LAKE COUNTY, FLORIDA
PUBLIC WORKS DEPARTMENT
CONSTRUCTION PLANS

SAWGRASS BAY BOULEVARD AND PACIFIC ACE WAY

SIGNALIZATION PLANS

REVISION PLANS
08/04/2023

SHEET NO.	T-7
-----------	-----

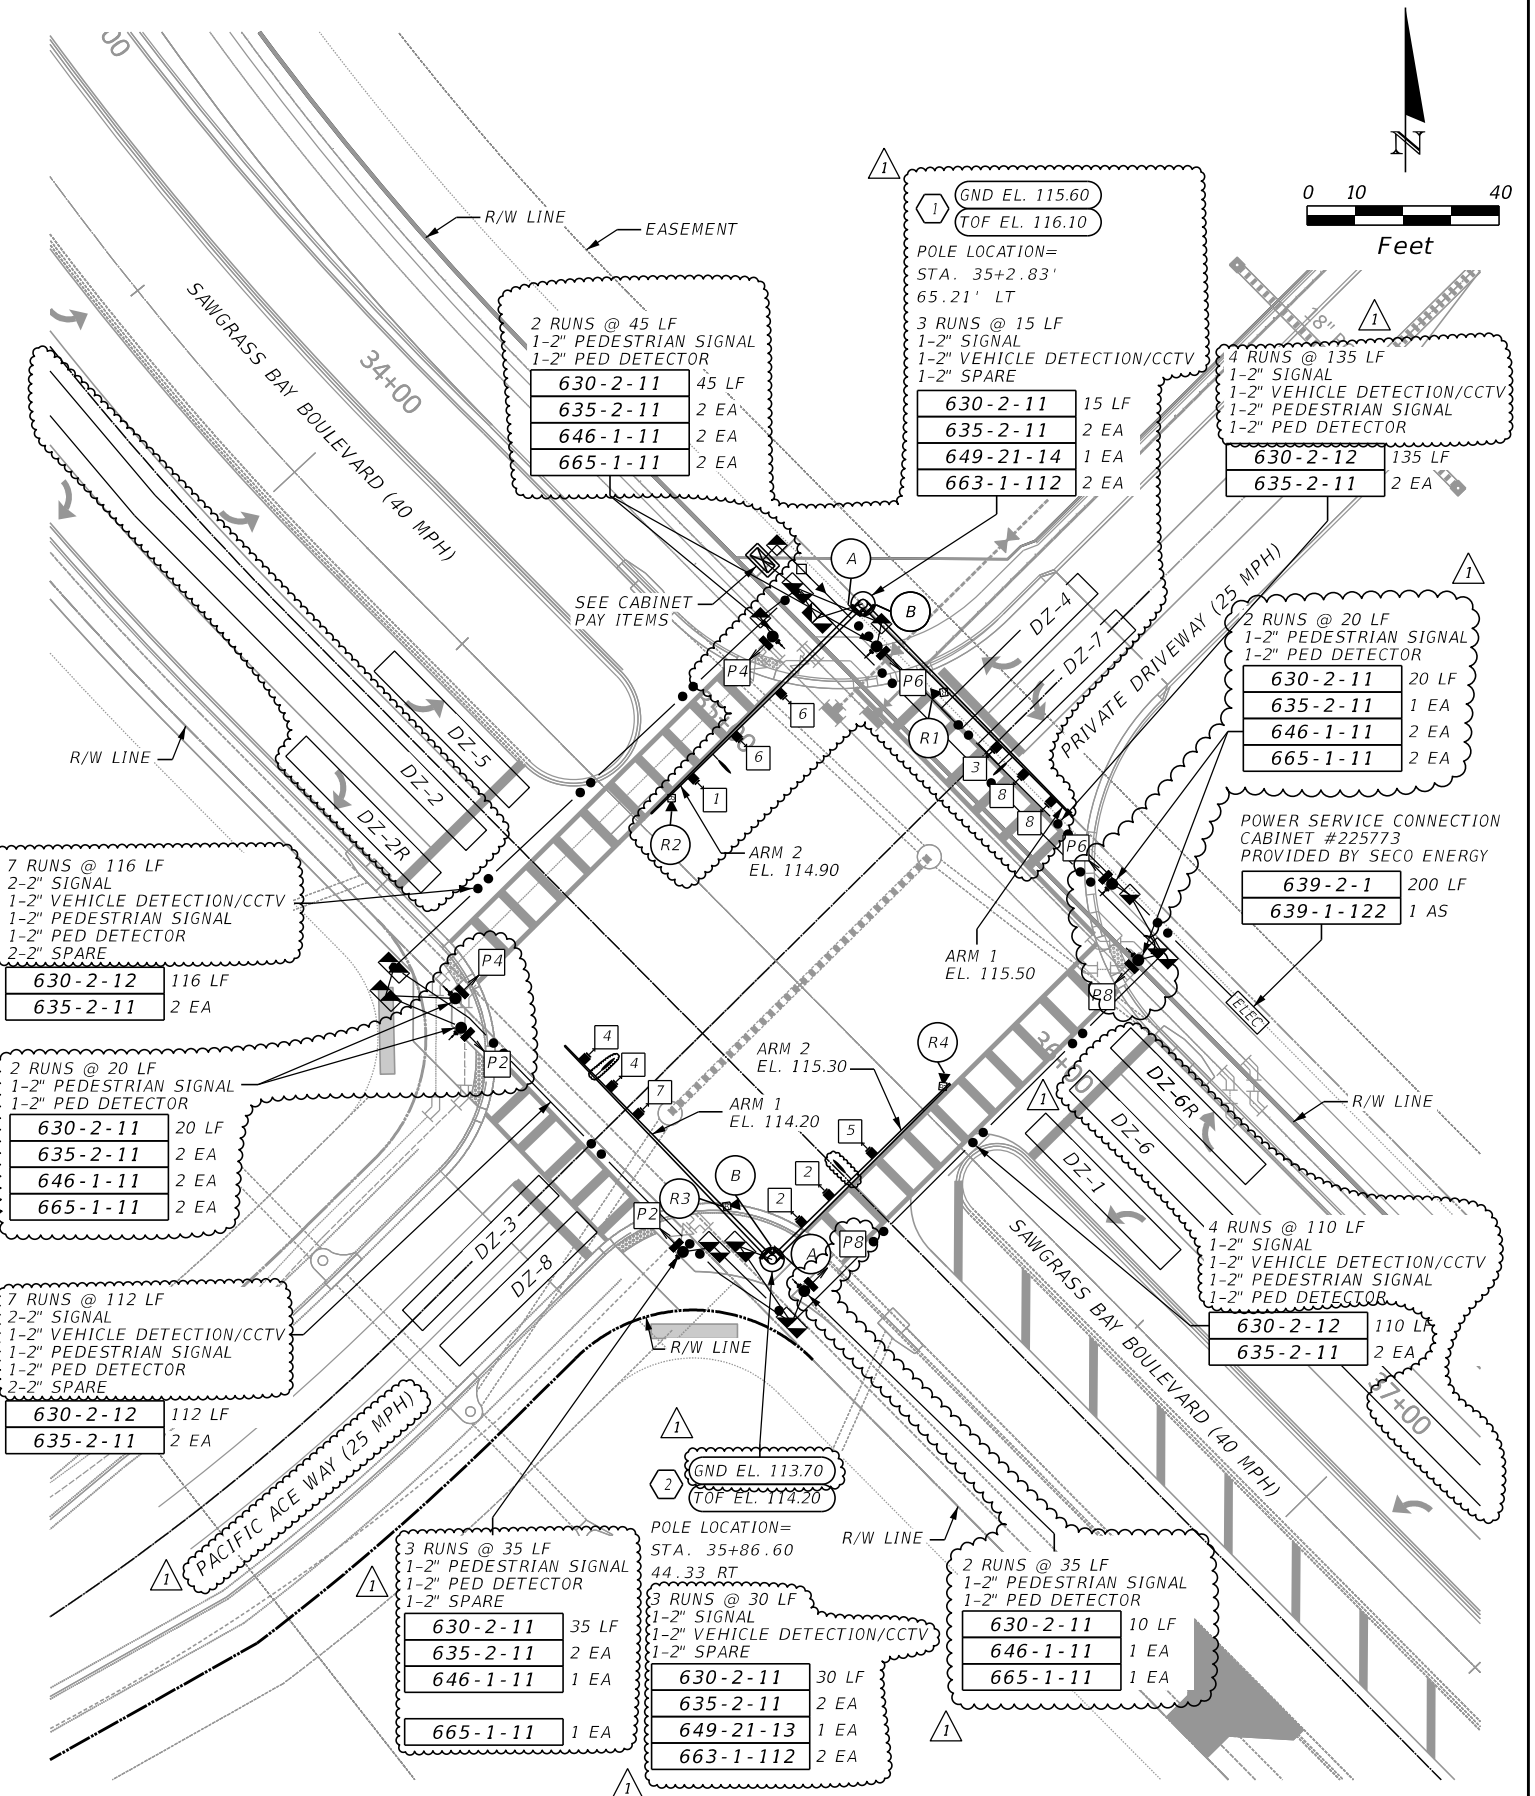
DATE	DESCRIPTION
08/02/23	POLE 1 LOCATION UPDATED AND PEDESTRIAN FEATURES ADDED TO ALL APPROACHES. PAY ITEMS AND DETAILS UPDATED.

SHEET NO.
T-8

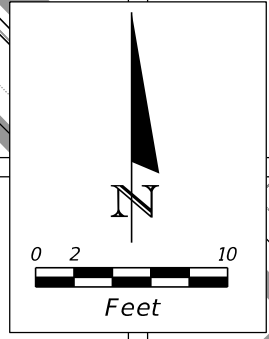
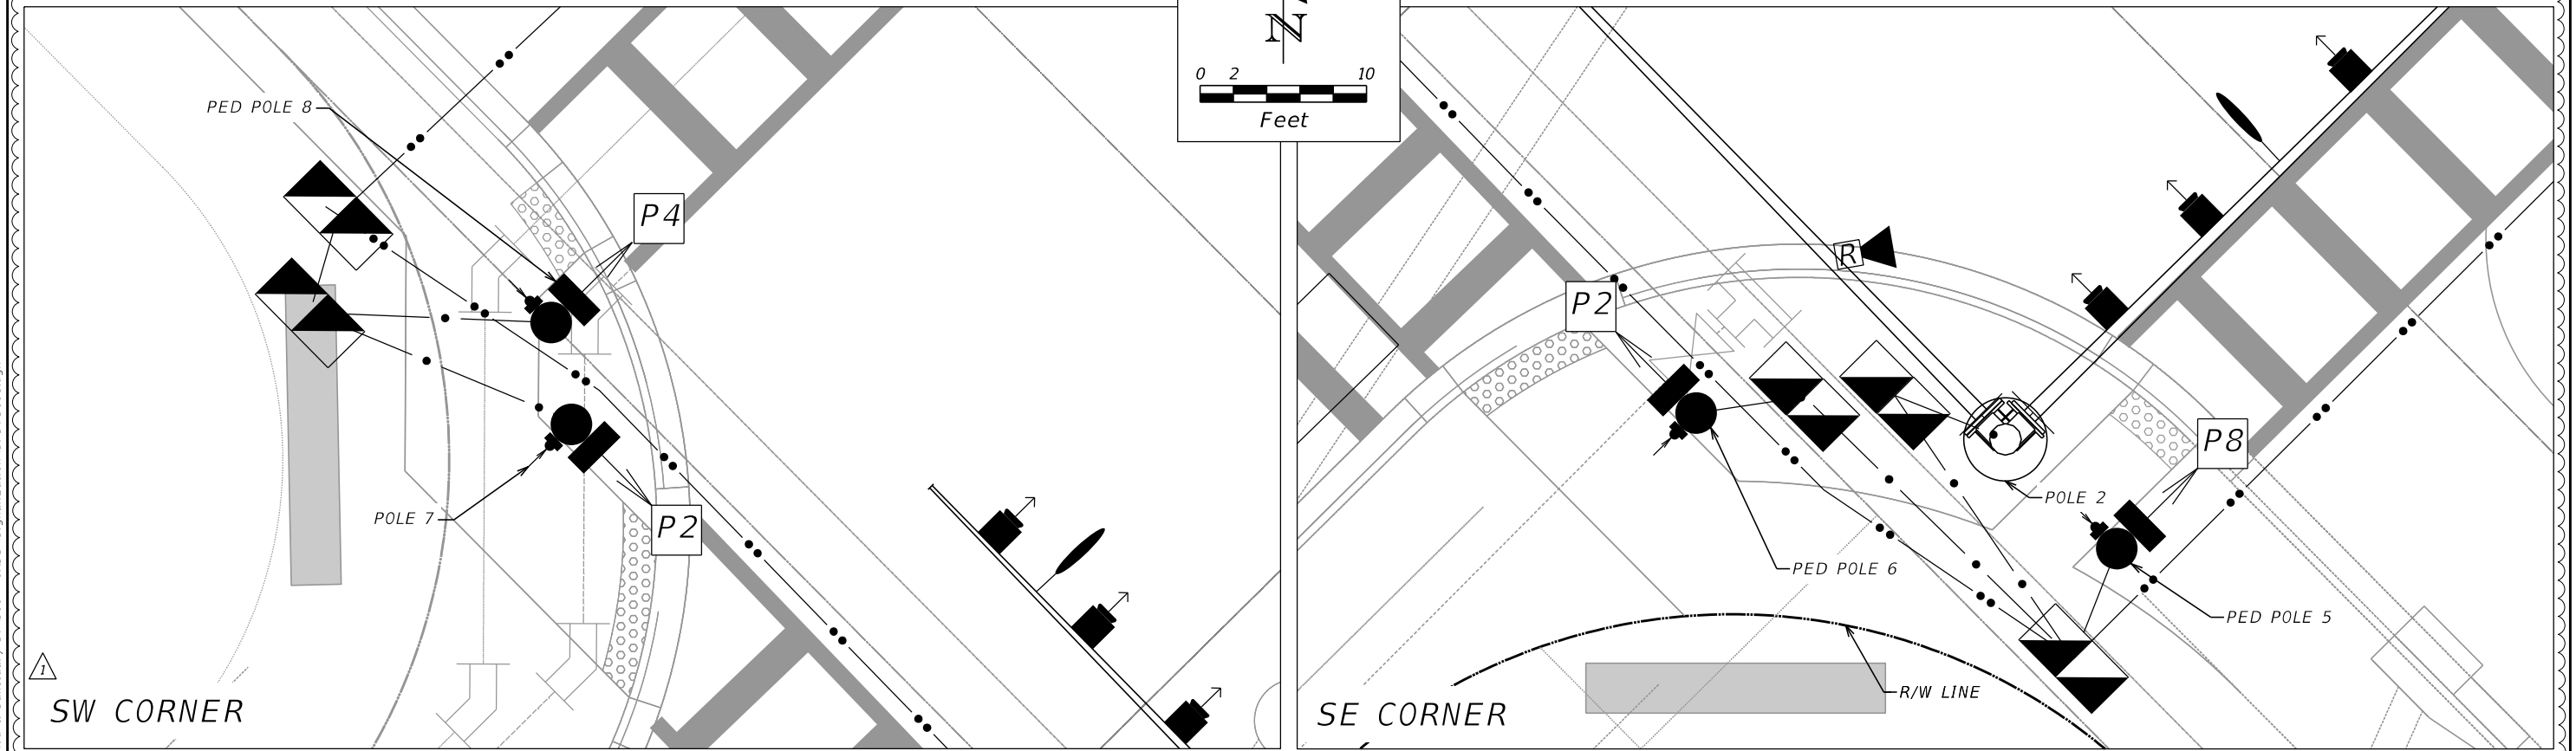
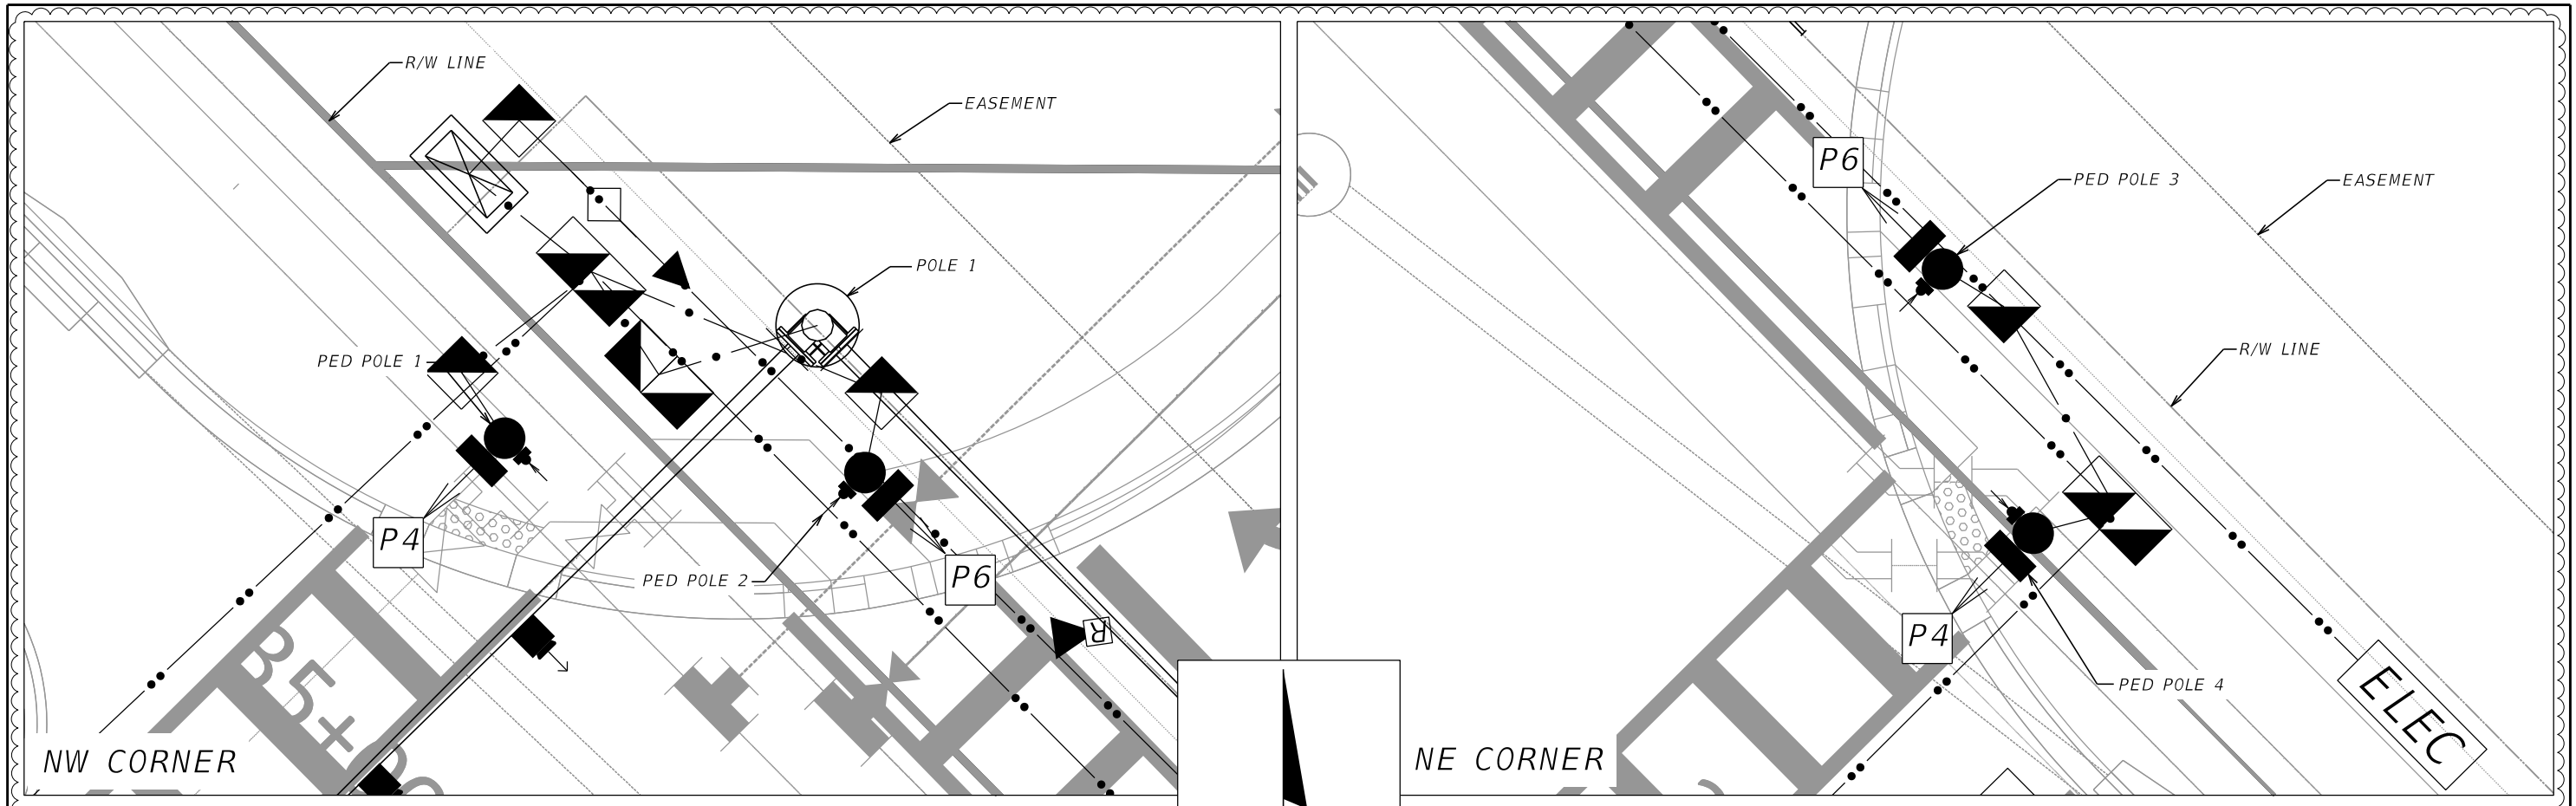
REVISIONS	
DATE	DESCRIPTION
08/04/23	CORNER CLIPS UPDATED TO REFLECT SIGNAL PLAN CHANGES

SHEET NO.
T-9

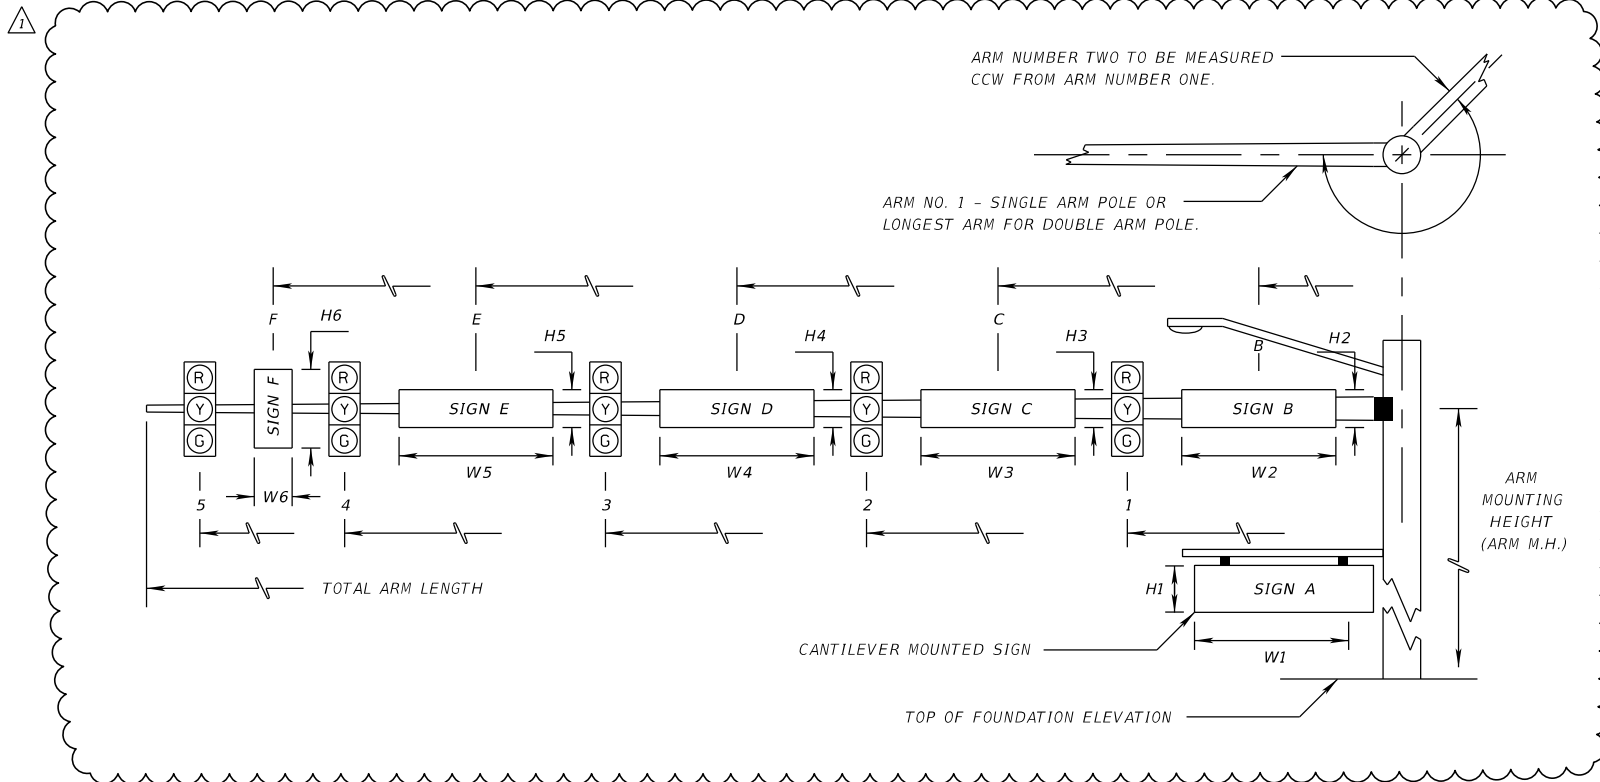
REVISIONS		DATE		DESCRIPTION	
08/04/23	1	UPDATED POLE 1 LOCATION AND LOADINGS DUE TO POLE SHIFT.		ADDED OVERHEAD SIGN TO TABLE.

SHEET NO.
T-11

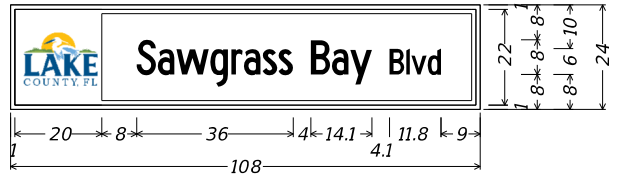
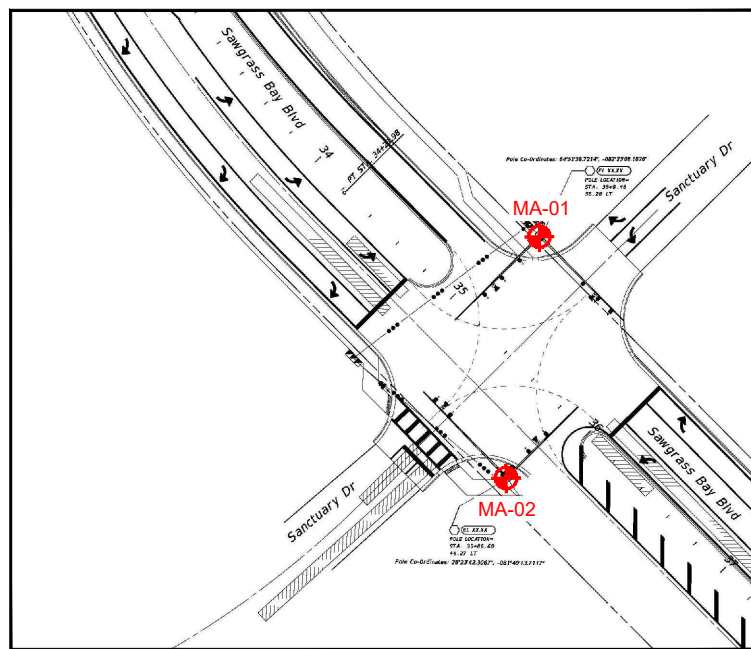
REVISIONS			
DATE	DESCRIPTION	DATE	DESCRIPTION
06/29/23	UPDATED STREET NAME AND ADDED MOUNTING NOTES.
